Planning Stage Structural Report

150 Day Street

Prepared for UOL / 20th March 2025

Issue: Revision 2

INTERNAL FOUNDATION STRENGTHENING STRATEGY

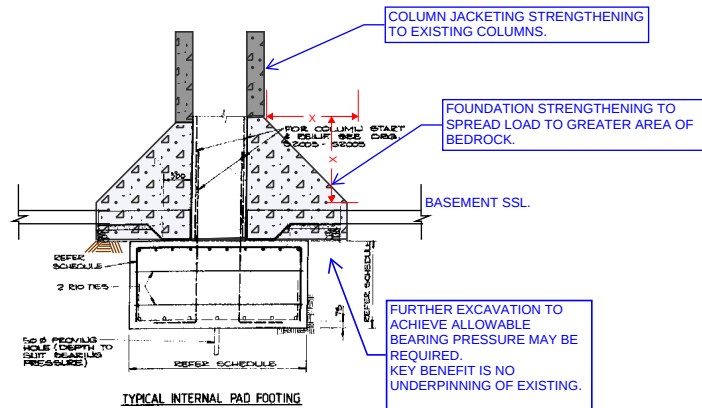
APPROXIMATE LOCATION OF GEOTECHNICAL
FAULT ZONE THROUGH SITE, WITH LOWER
ALLOWABLE BEARING CAPACITY

APPROXIMATE LOCATION OF CROSS
CITY TUNNEL.
DEPTH AND LOCATION TO BE
CONFIRMED, ALLOW FOR
CONSULTATION WITH STAKEHOLDERS
TO DISCUSS IMPLICATIONS OF
ADDITIONAL STOREYS ON FOUNDATION
FORCES.

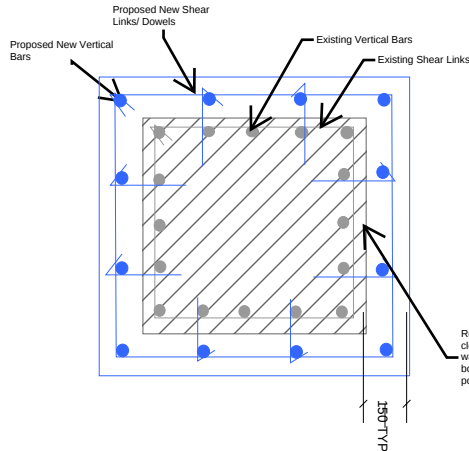
EXISTING LIFT CORE TO BE STRENGTHENED
BY WRAPPING WITH 350 THICK CONCRETE.
FOOTING STRENGTHENING VIA
UNDERPINNING SHOULD BE ALLOWED FOR AT
EXISTING LIFT LOCATION.

GENERAL STRATEGY AT PERIMETER COLUMNS:

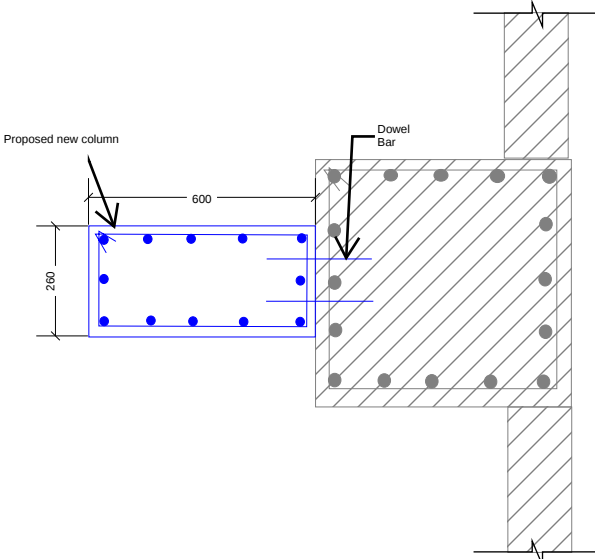
ALLOW FOR INTERNAL RETURN COLUMN ON INSIDE FACE. NEW LOADS FROM
ADDITIONAL STOREYS TO LOAD DIRECTLY INTO THESE EXTENSIONS.
PLAN GEOMETRY OF STRENGTHENED SECTION MAY BE MODIFIED, AT TYPICAL
HOTEL FLOOR INTENTION IS FOR COLUMN TO FIT WITHIN HOTEL WALL.

1 L03 PLAN
RS_020 1:200

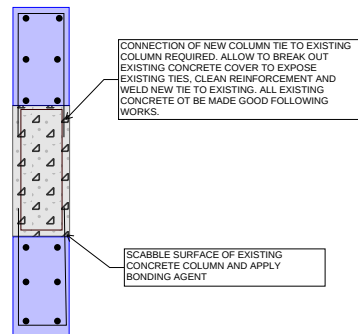
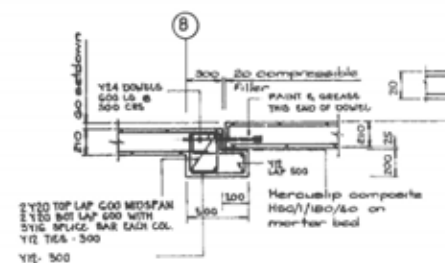
EXISTING FIRE STAIR AND ATRIUM VOID IN
FILLED WITH STRUCTURAL STEEL BEAMS AND
BONDEK IN ARRANGEMENT SHOWN.

GENERAL SOLUTION TO INFILL EXISTING
STAIR VOIDS WITH BONDEK AND
STRUCTURAL STEEL FRAMING.

THERE IS AN EXITING BUILDING JOINT AT GRID 8 WHICH STRUCTURALLY SEPARATES THE STRUCTURE TO THE NORTH AND SOUTH OF THIS LINE FROM THE BASE TO THE TOP OF THE EXISTING STRUCTURE. STEEL PLATES WILL BE USED TO TIE TOGETHER THE STRUCTURE ACROSS THIS JOINT AT ALL FLOORS SO THAT THE BUILDING BEHAVES ROBUSTLY AS A SINGLE STRUCTURAL ELEMENT.

1 L04 PLAN
RS_020 1:200

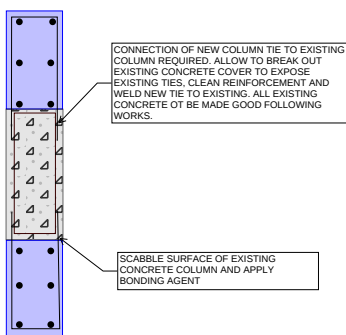
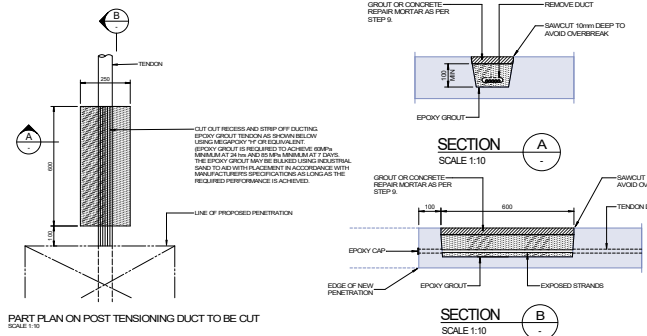
EXISTING FIRE STAIR AND ATRIUM VOID IN FILLED WITH STRUCTURAL STEEL BEAMS AND BONDEK IN ARRANGEMENT SHOWN.

NOTE ON REQUIREMENTS FOR TRUNCATING EXISTING POST-TENSIONING.

FOR NEW LIFT AND STAIR SOUTH OF GRID E8 IN PARTICULAR.

TRUNCATION OF EXISTING POST-TENSIONING WILL BE REQUIRED TO FORM NEW OPENING FOR LIFT AND STAIR VOID. DETAILED ANALYSIS REQUIRED AT NEXT DESIGN STAGE IN ORDER TO ASSESS ANY ADDITIONAL STRENGTHENING IN ADJACENT SLAB WHICH MAY BE REQUIRED TO FACILITATE THIS TRUNCATION.

3. For each tendon to be cut, carefully remove a 600 long by 250 wide strip of concrete from above and around the tendon 50mm from the penetration. DO NOT CUT ANY REINFORCEMENT. Strip off the slabs and clean out the existing grout.

7. Cut the slab into manageable chunks and remove them.
8. Remove the platform and props.
9. Fill top portion of strip with 21 sand cement grout or Rendicrete HF for internal applications and Rendicrete HB40 Plus for external applications or areas with no applied finishes. Fill in to be finished slab with surrounding concrete surface.

1 L11 PLAN - TRANSFER FLOOR

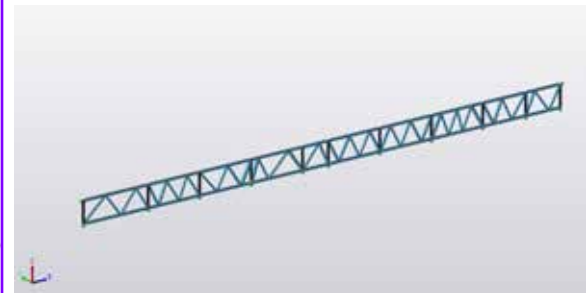
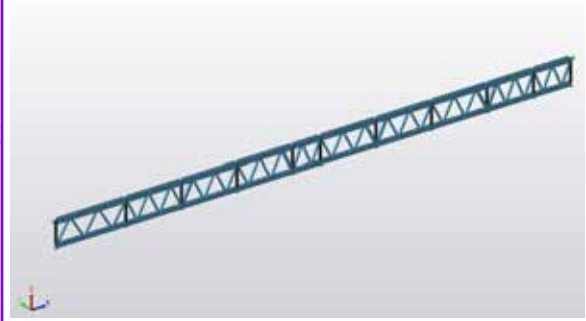
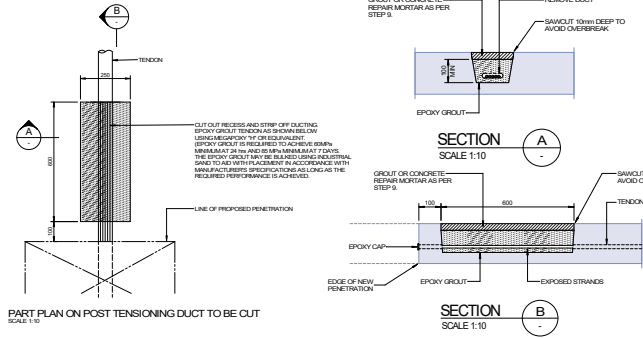
GENERAL STRUCTURAL SOLUTION TO PROVIDE FULL STOREY STEEL TRUSSES TO TRANSFER COLUMN LOADS AT THIS STOREY.

NOMINALLY, AN IRREGULAR TRUSS WITH OPTIMISED GEOMETRY WILL REQUIRE APPROXIMATELY HALF THE STEEL TONNAGE OF A REGULAR TRUSS.

OPTION 1: OPTIMISED IRREGULAR TRUSS
TOTAL STEEL WEIGHT FOR COSTING, APPROXIMATELY 450kg/m

OPTION 2: NON-OPTIMISED REGULAR TRUSS
TOTAL STEEL WEIGHT FOR COSTING, APPROXIMATELY 1100kg/m

NOTE ON PROPOSED USE OF GYM AREA
GENERALLY ALLOW FOR SUB-FLOOR OR ACCESS FLOOR WITHIN GYM AREA TO MINIMISE IMPACT OF VIBRATION PROPAGATION THROUGH STRUCTURE.

SOME DEGREE OF STRUCTURAL STRENGTHENING LIKELY REQUIRED IN GYM AREA IN ORDER TO INCREASE EXISTING CAPACITY TO REQUIRED LEVEL. EXTENT OF STRENGTHENING TO BE ADVISED FOLLOWING DETAILED INVESTIGATION OF EXISTING CAPACITY AND WEIGHTS OF EXISTING FINISHES.

NOTE ON DEEP PLANTER ZONE AND INTEGRATED TEMPORARY WORKS DECK AT L11
INCLUSION OF DEEP PLANTER ZONE AT L11 WILL REQUIRE EXTENSIVE STRENGTHENING OF EXISTING STRUCTURE DUE TO INCREASED WEIGHT.

STRUCTURAL REQUIREMENTS TO SUPPORT WEIGHT OF POOL PLANT MUST BE REVIEWED IN DETAIL WITH INPUT FROM A POOL CONSULTANT.

TRUNCATION OF EXISTING POST-TENSIONING WILL BE REQUIRED TO FORM NEW OPENING FOR LIFT AND STAIR VOID.

DETAILED ANALYSIS REQUIRED AT NEXT DESIGN STAGE IN ORDER TO ASSESS ANY ADDITIONAL STRENGTHENING IN ADJACENT SLAB WHICH MAY BE REQUIRED TO FACILITATE THIS TRUNCATION.

3. For each tendon to be cut, carefully remove a 600 long by 250 wide strip of concrete from above and around the tendon 100mm from the penetration. DO NOT CUT ANY REINFORCEMENT. Strip off the slating and clean out the existing grout.

7. Cut the slab into manageable chunks and remove them.
8. Remove the platform and props.
9. Fill top portion of strip with 3:1 sand cement grout or 'Rendicrete-HF' for internal applications and 'Rendicrete-H40 Plus' for external applications or areas with no applied finishes. HF is to be finished flush with surrounding concrete surface.

1 L18 PLAN
RS_200 1:200

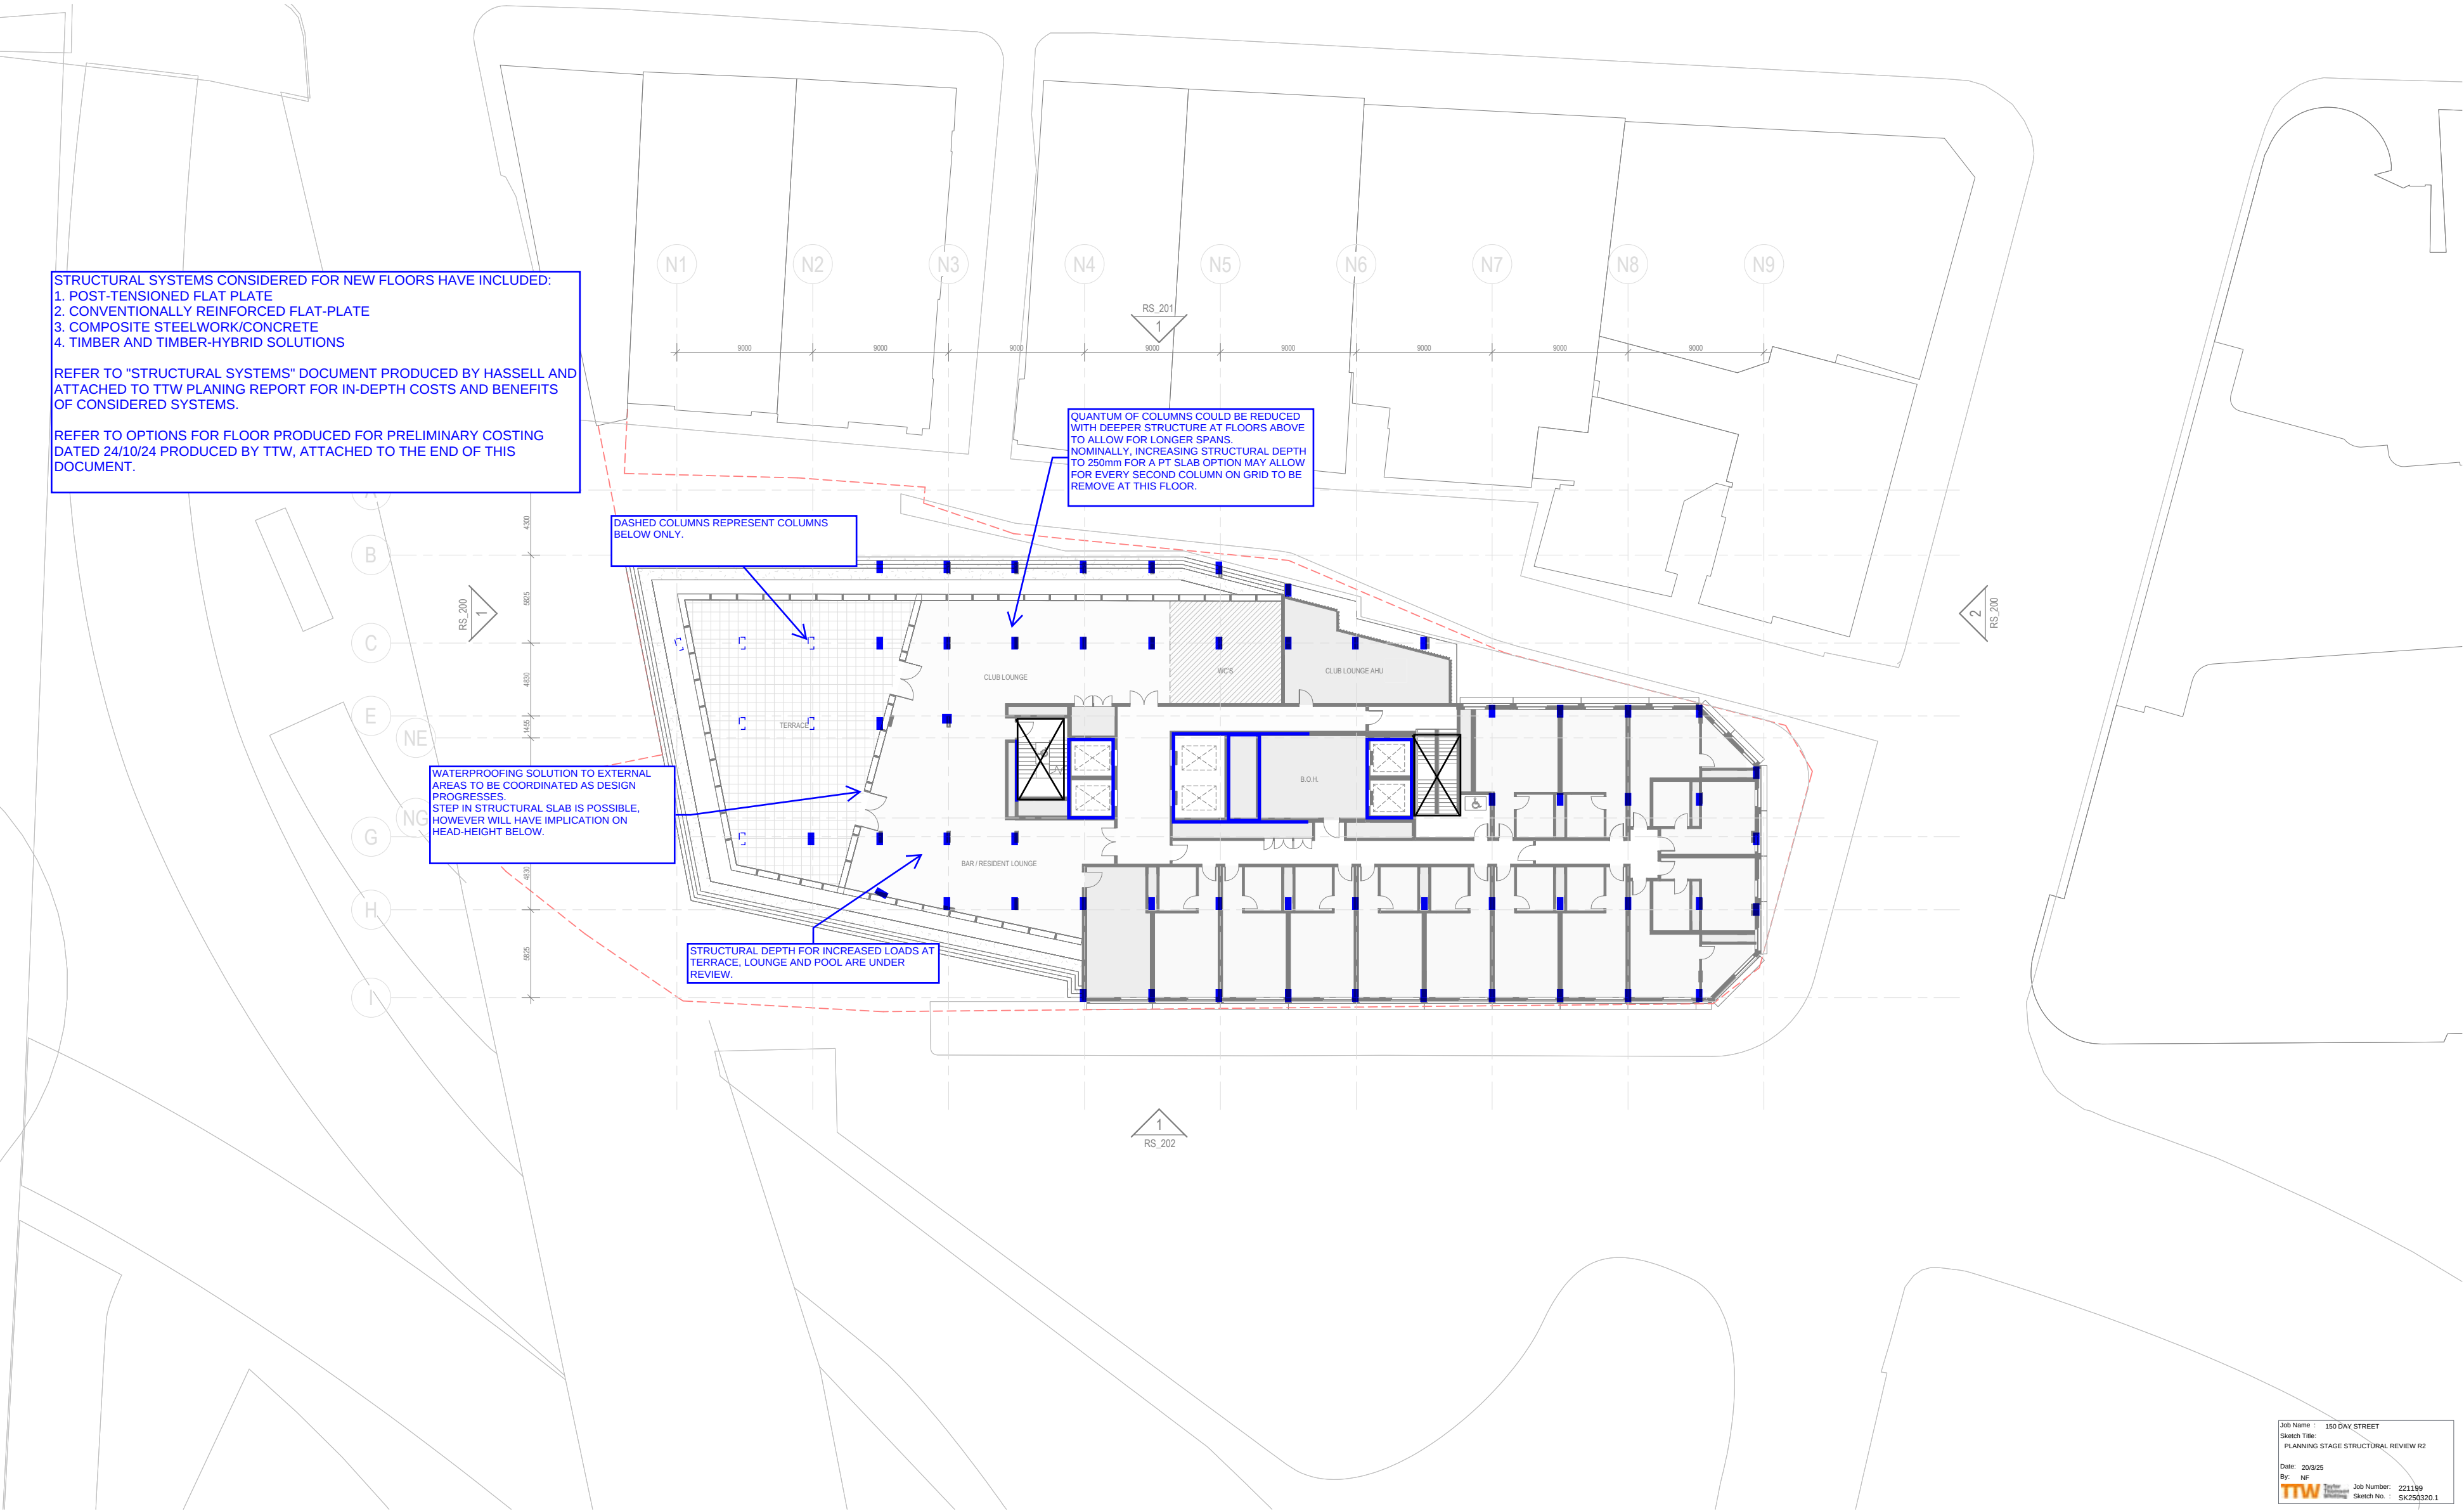
REFER TO OPTIONS FOR FLOOR PRODUCED FOR PRELIMINARY COSTING DATED 24/10/24 PRODUCED BY TTW, ATTACHED TO THE END OF THIS DOCUMENT.

DASHED COLUMNS REPRESENT COLUMNS BELOW ONLY.

QUANTUM OF COLUMNS COULD BE REDUCED WITH DEEPER STRUCTURE AT FLOORS ABOVE TO ALLOW FOR LONGER SPANS. NOMINALLY, INCREASING STRUCTURAL DEPTH TO 250mm FOR A PT SLAB OPTION MAY ALLOW FOR EVERY SECOND COLUMN ON GRID TO BE REMOVE AT THIS FLOOR.

1 L19 PLAN
RS_200 1:200

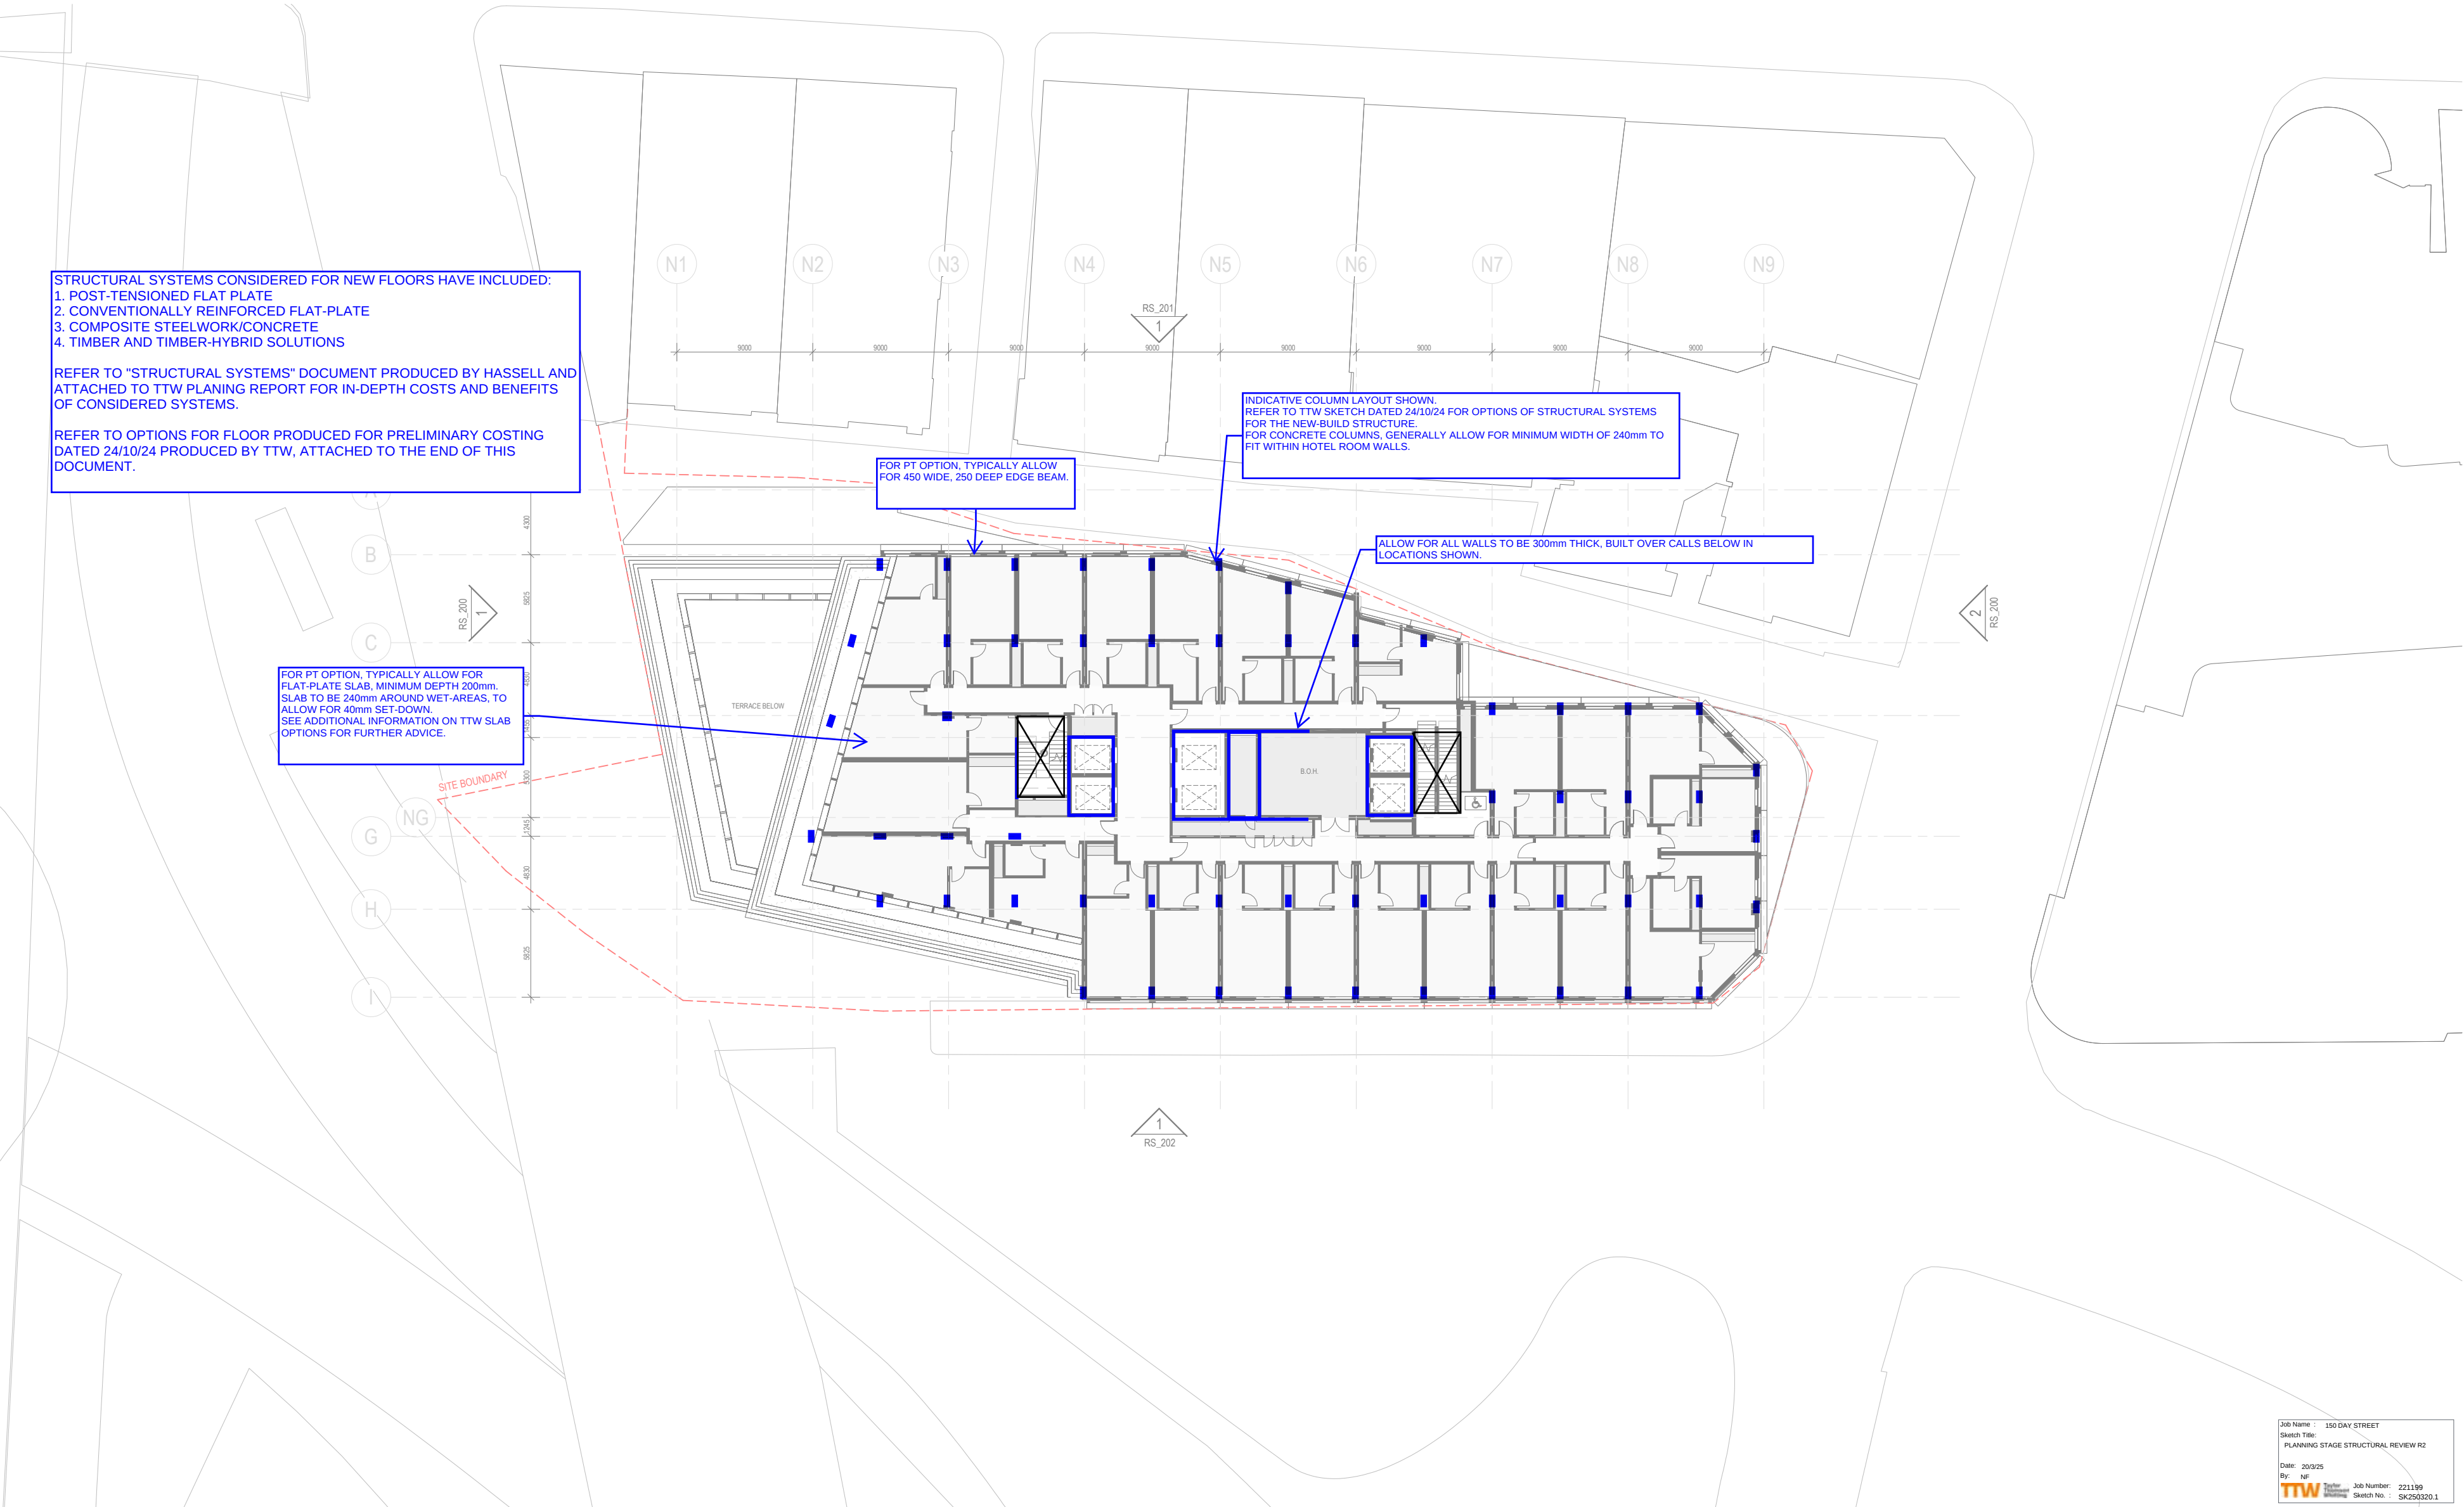
FOR PT OPTION, TYPICALLY ALLOW FOR FLAT-PLATE SLAB, MINIMUM DEPTH 200mm. SLAB TO BE 240mm AROUND WET-AREAS, TO ALLOW FOR 40mm SET-DOWN. SEE ADDITIONAL INFORMATION ON TTW SLAB OPTIONS FOR FURTHER ADVICE.
